CITY OF MOUNTAIN VIEW
MOUNTAIN VIEW, CALIFORNIA
ADDENDUM NO. 2
TO CONTRACT DOCUMENTS AND SPECIFICATIONS
FOR
FIRE STATION NO. 5, PROJECT 09-32

Changes to Construction Drawings

MOUNTAIN VIEW FIRE STATION No. 5

Issued As: ADDENDUM 2
Sketch Number: ESK-14
Date: 05-21-10

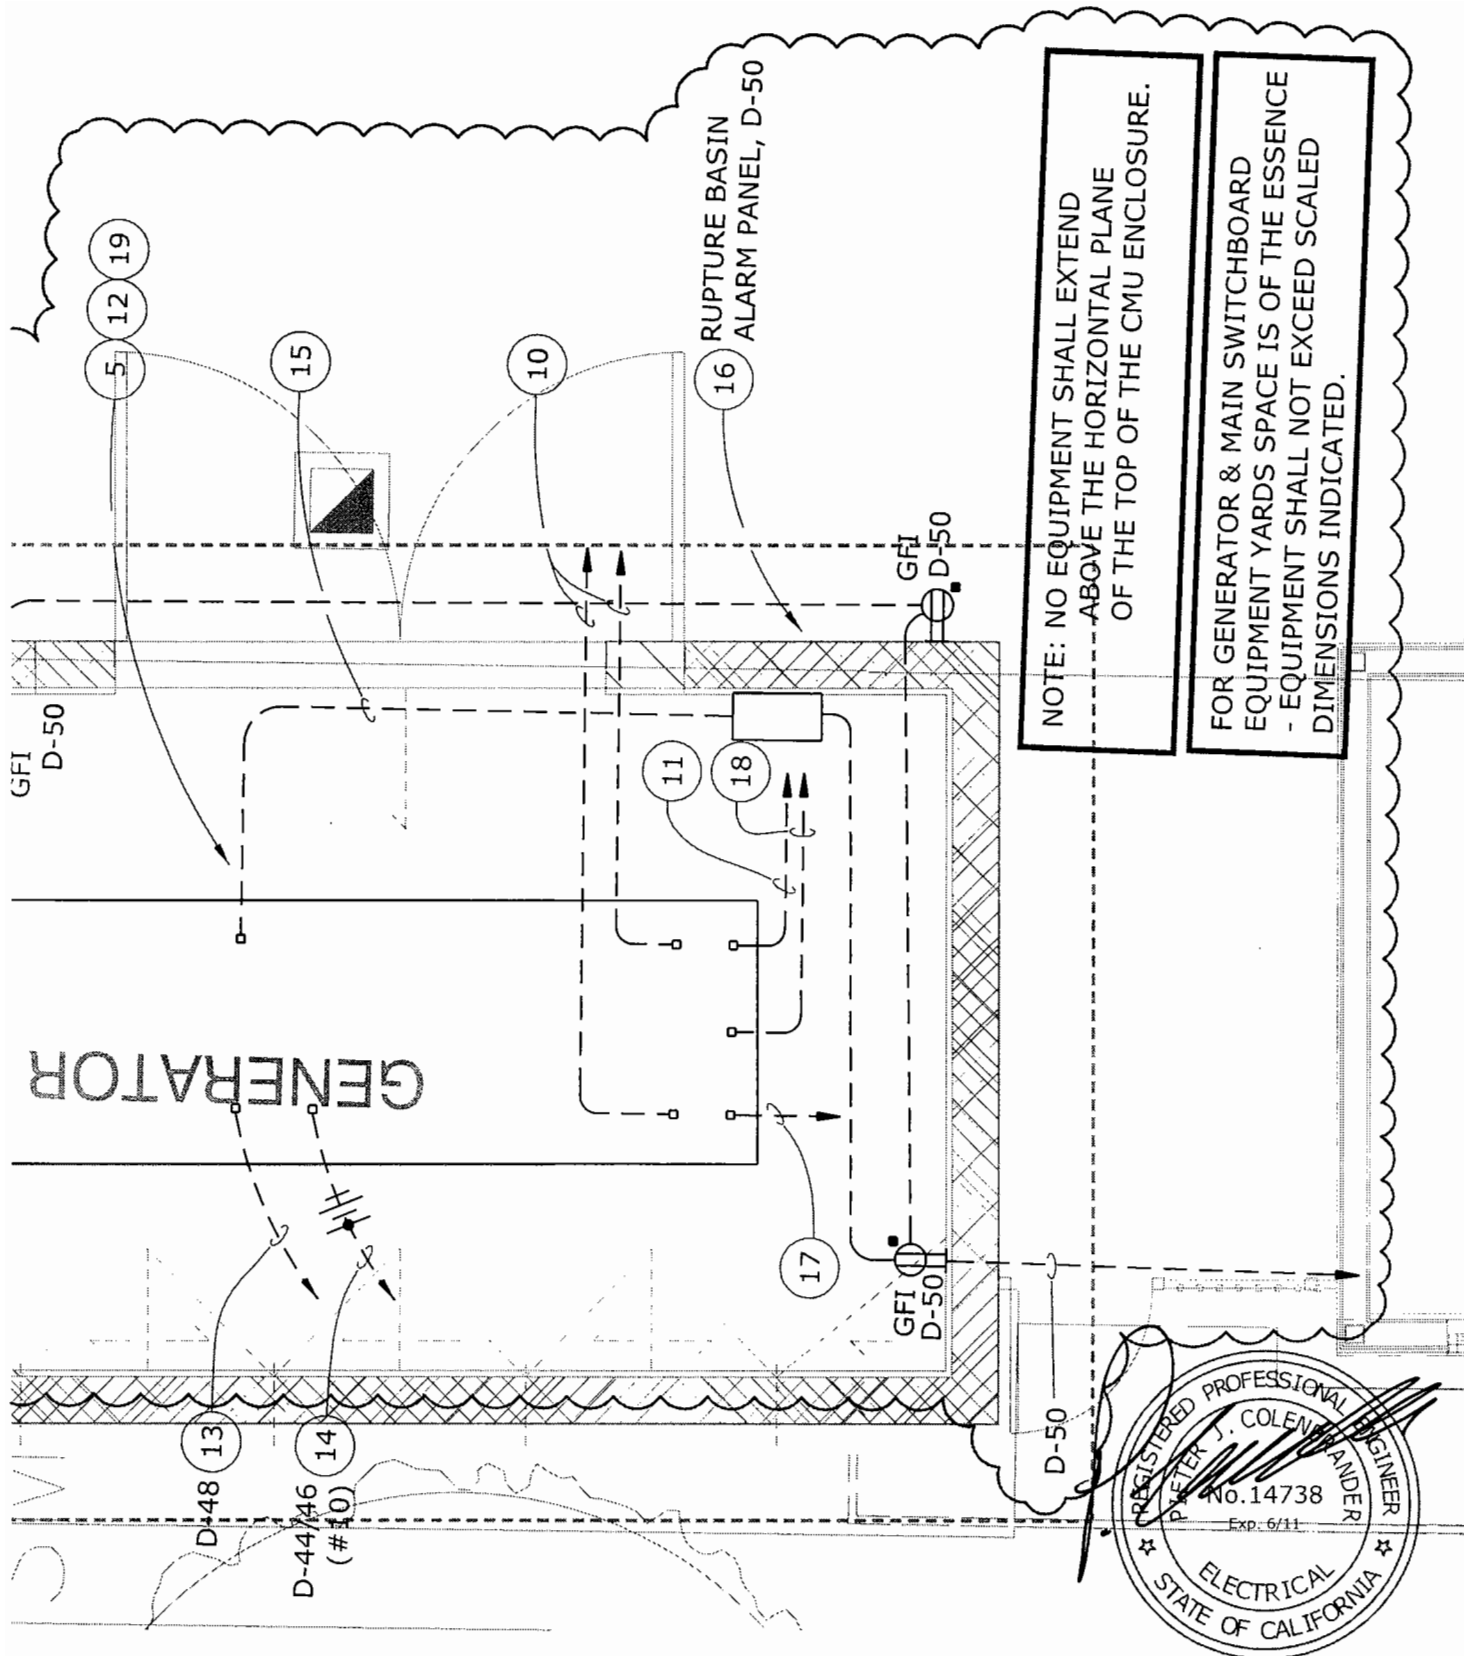
Sketch ESK-14 & 15: Generator footprint revised. Generator enclosure revised. Reference to Structural drawings for slab/foundation added. Receptacle relocated.

3
E7.2

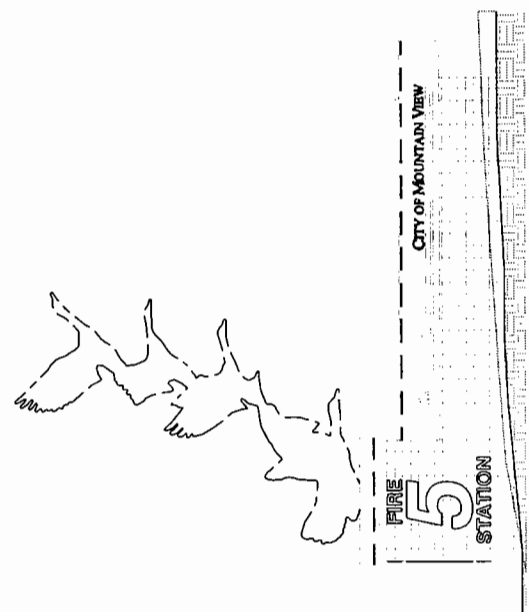
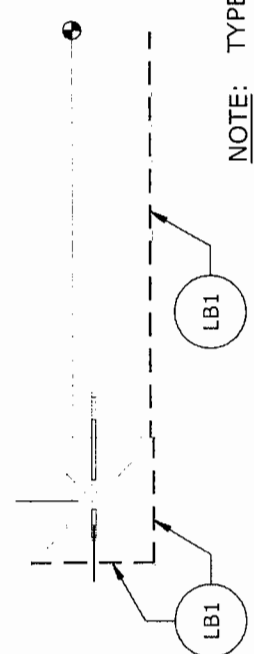
Sketch ESK- 21: Detail 3/E7.2 (Generator pad detail removed) and replaced with new detail for Monument Sign Lighting. Add the following note: "Provide an allowance for 3 exterior light fixtures focused on the sculpture at the monument sign, type MD1, in ground mounting with concrete mow collar. Fixtures are to be connected to monument sign time clock."

NOTE: TYPE LB1 CONCEALED STRIPLIGHT MOUNTED IN ARCHITECTURAL CHANNEL. CONNECT COMPLETE TO REMOTE TRANSFORMER. VERIFY LOCATION PRIOR TO ROUGH-IN.

ELECTRICAL SITE PLAN - DEMOLITION & RELOCATION

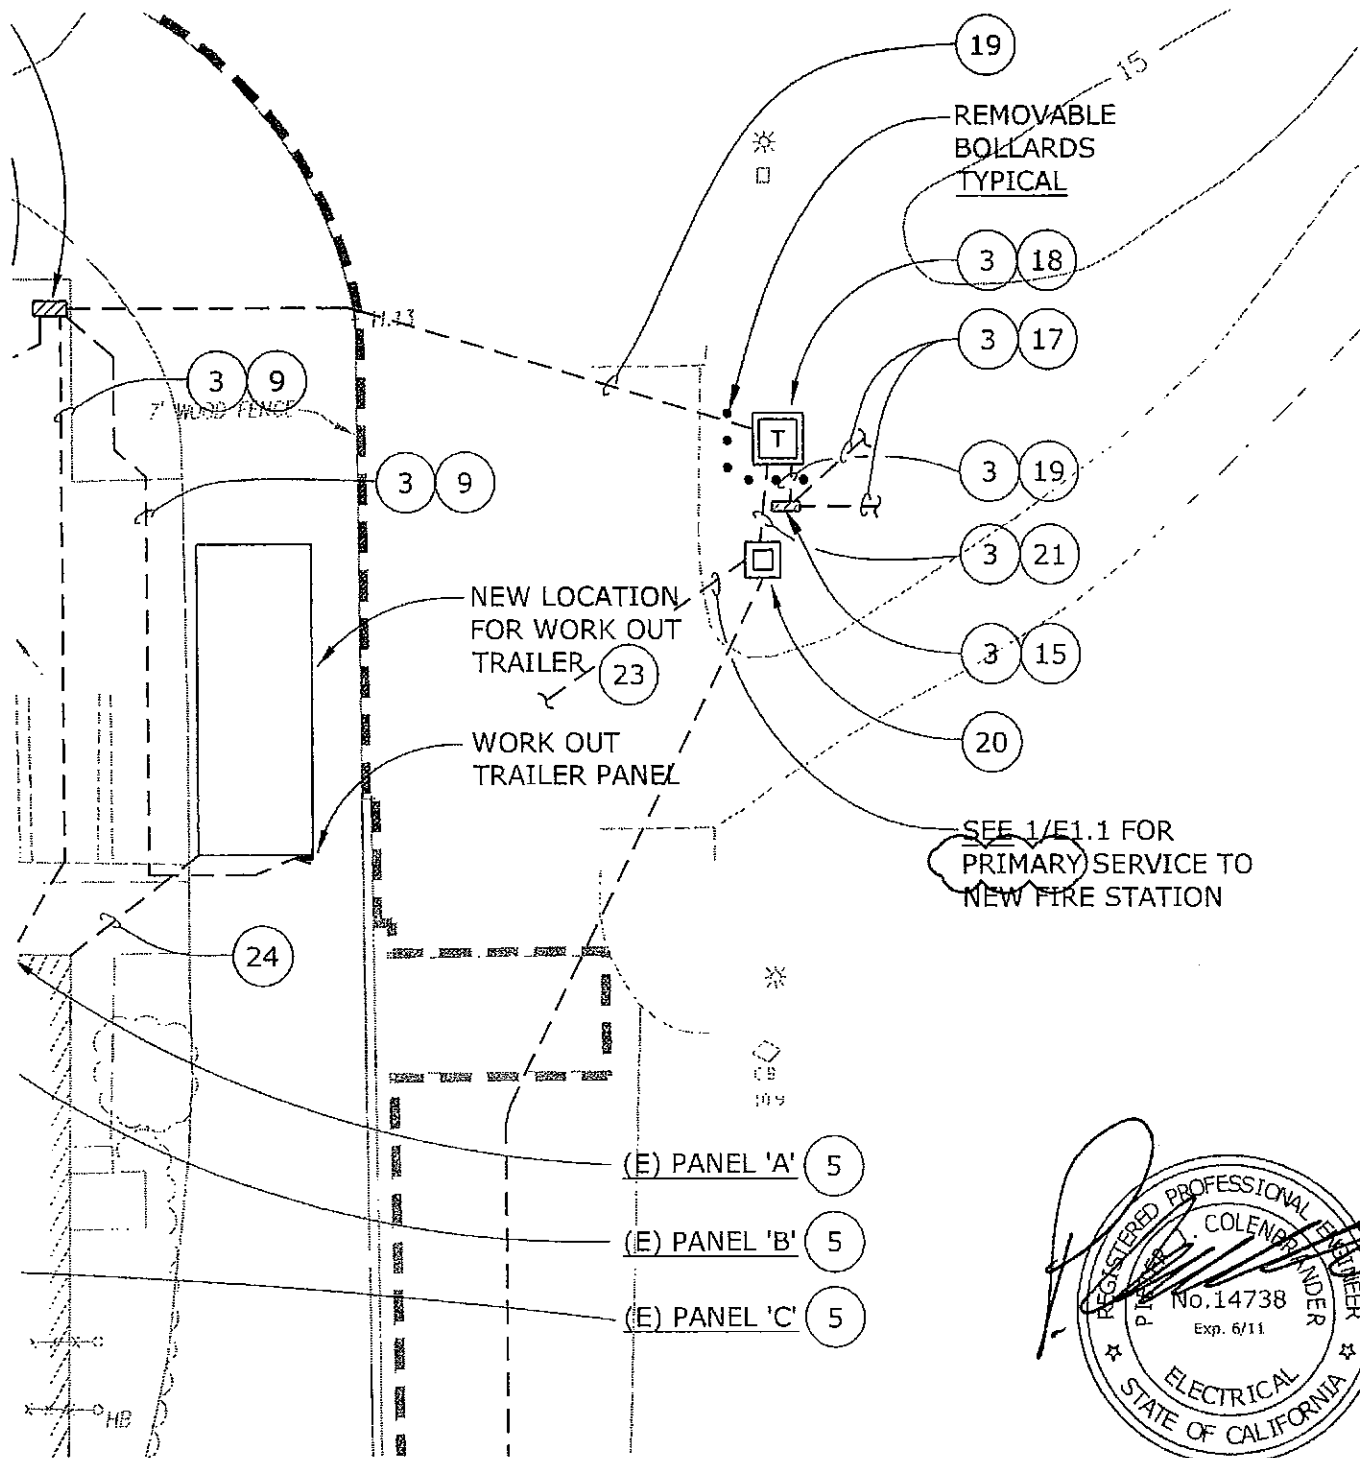
Sketch ESK-22: Note on PG&E conduits changed from "Secondary" to "Primary."
